ADDENDUM NUMBER: 5
PROJECT: **UNC Charlotte Residence Hall Phase XIV - Early Site Packages**

DATE: **March 4, 2015**
OWNER: **UNC Charlotte**
ARCHITECT: **FWA Group**

Early Site Package Pre-Bid RFI #1

Early Site Package Pre-Bid RFI #2

FOUNDATION DETAILS

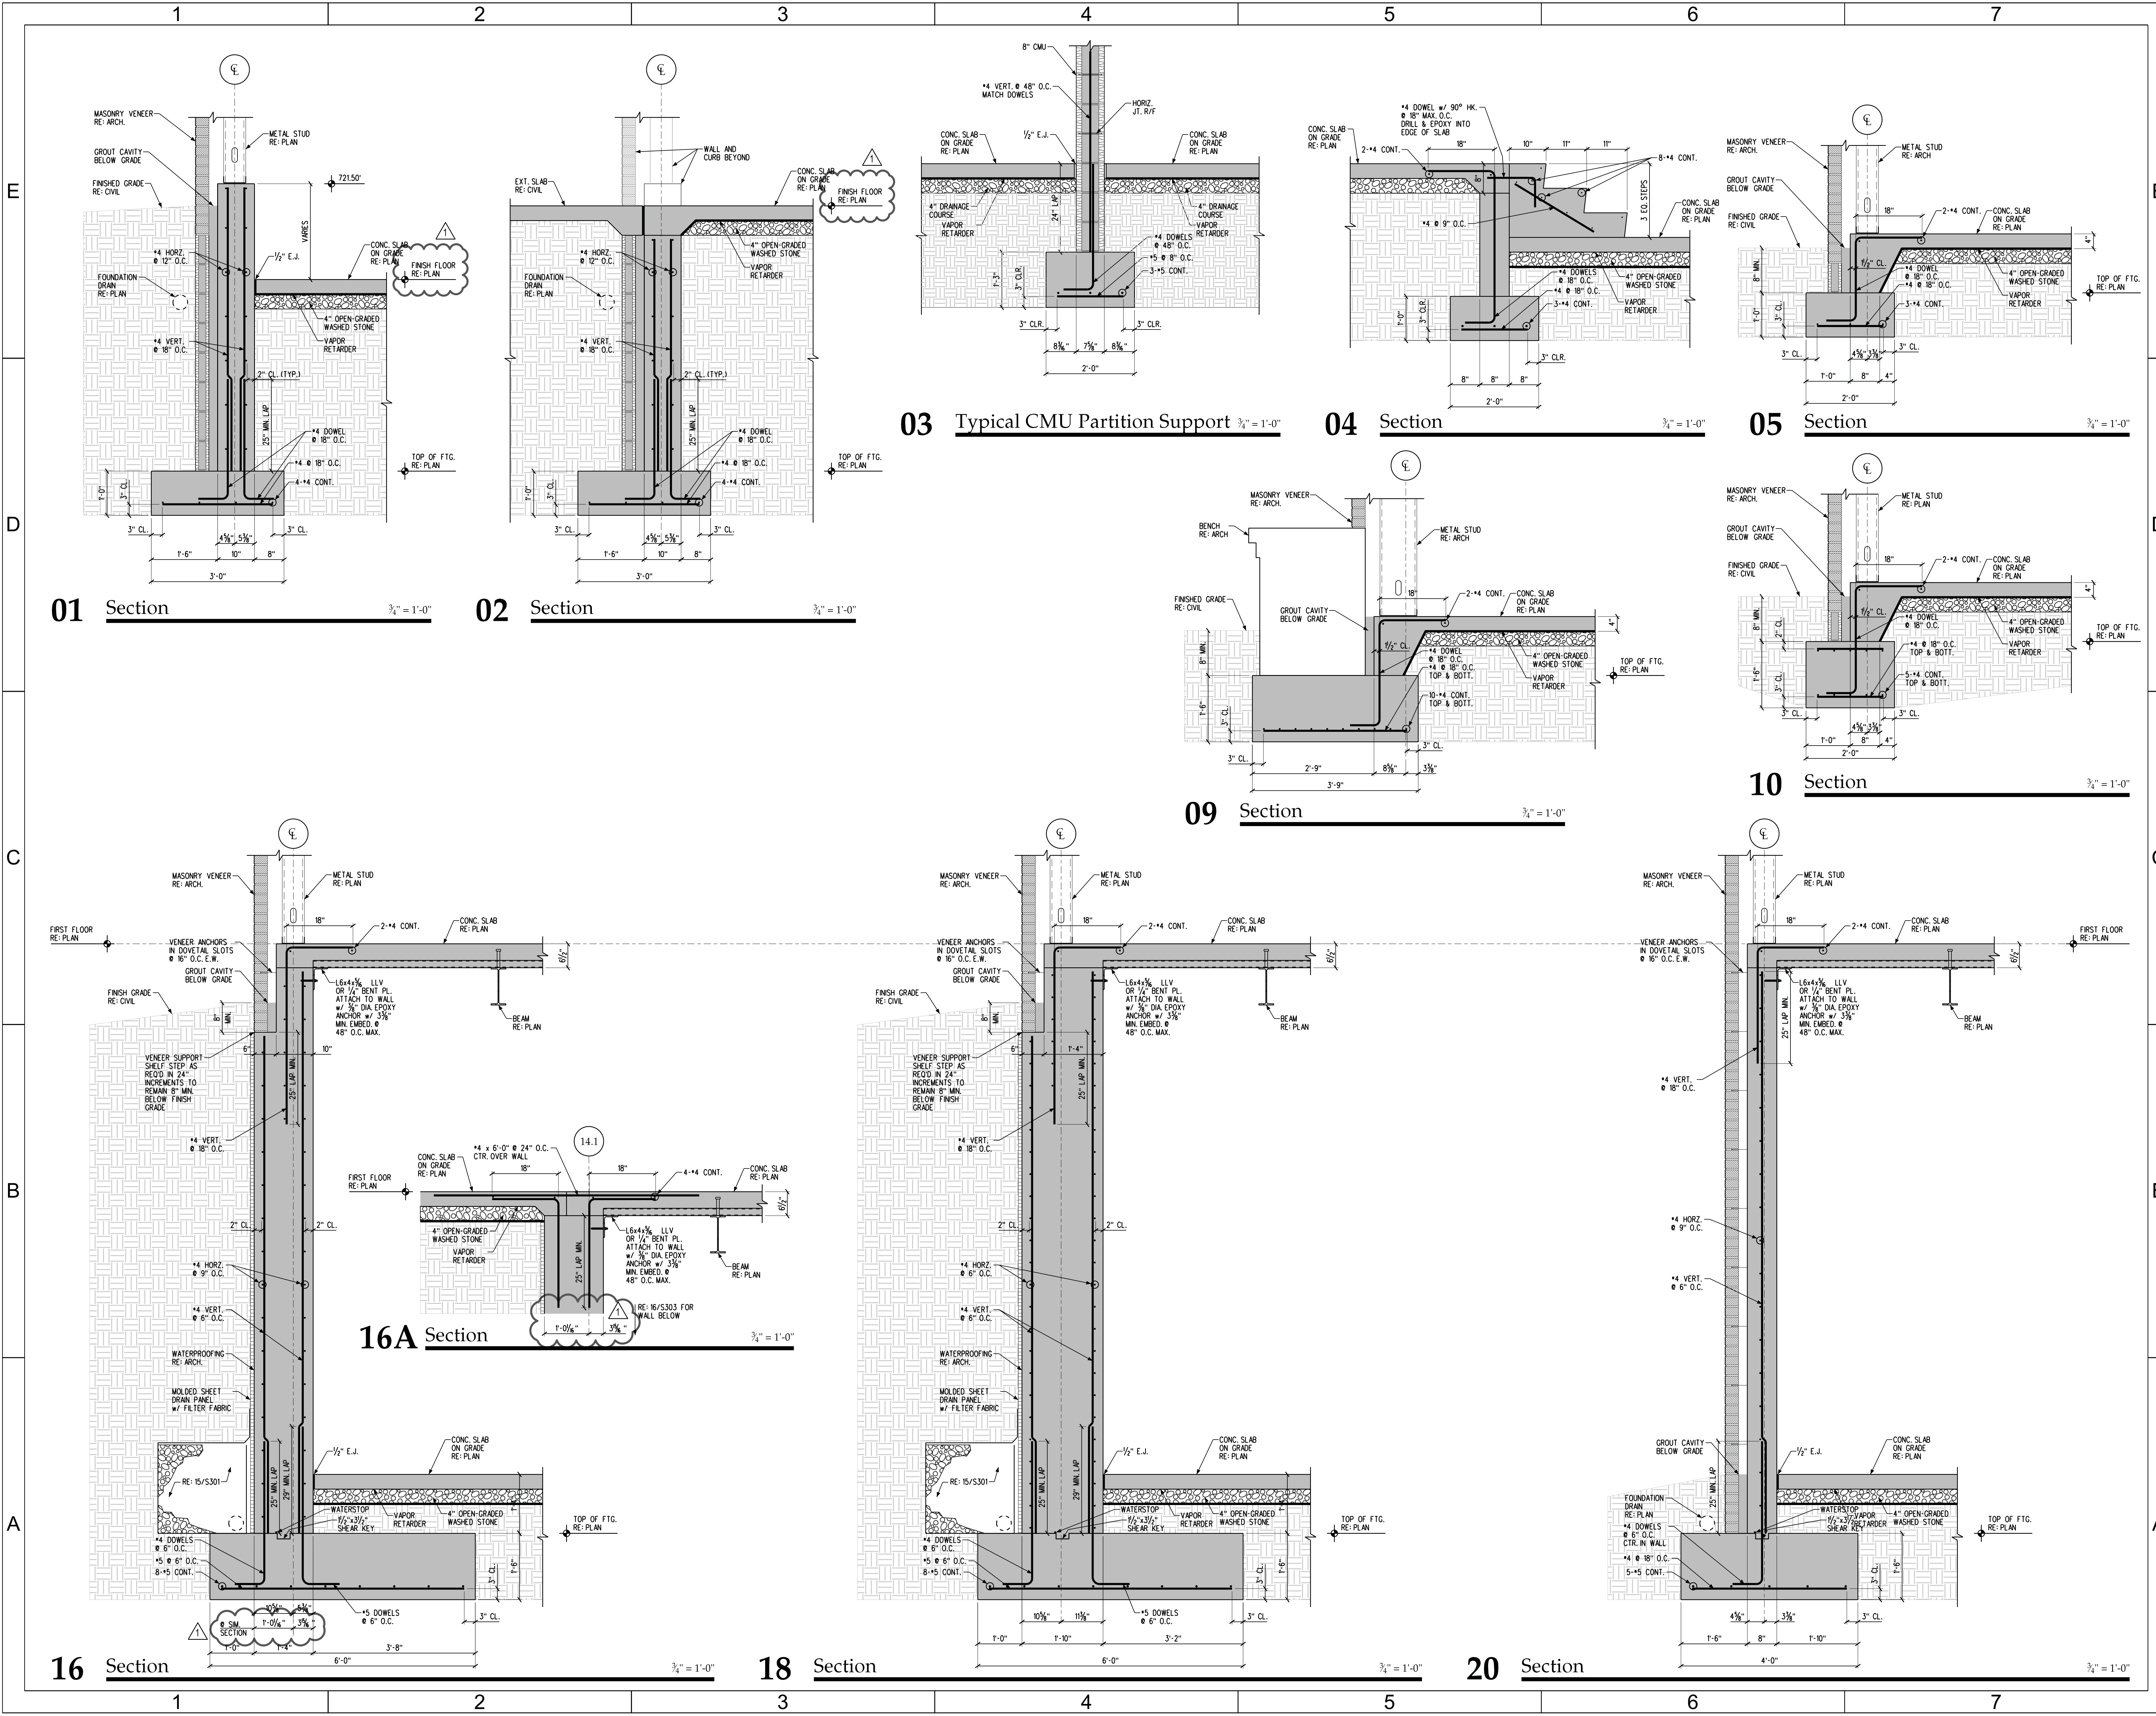
Answer:	BSDE Response: This correction has been made to the drawings. See FWA Addendum #02.
14	Section 2/S303 indicates the top of a foundation wall below the first floor finish floor- please confirm this should be basement slab elevation.

Answer:	BSDE Response: Details on 01 & 02 on S303 have been revised to eliminate the reference to "first floor". See FWA Addendum #02.
15	Please verify height of central elevator pit walls on S101-N. Section detail 4/S302 shows max height of 6'-6" and does not show a concrete wall extending above slab on grade. However, S201-N indicates a CB1 concrete beam over elevator door at level 1 and the top of adjacent P4A piers are at 731.42. Please confirm if the elevator pit walls should extend to level 1 and provide any required details.
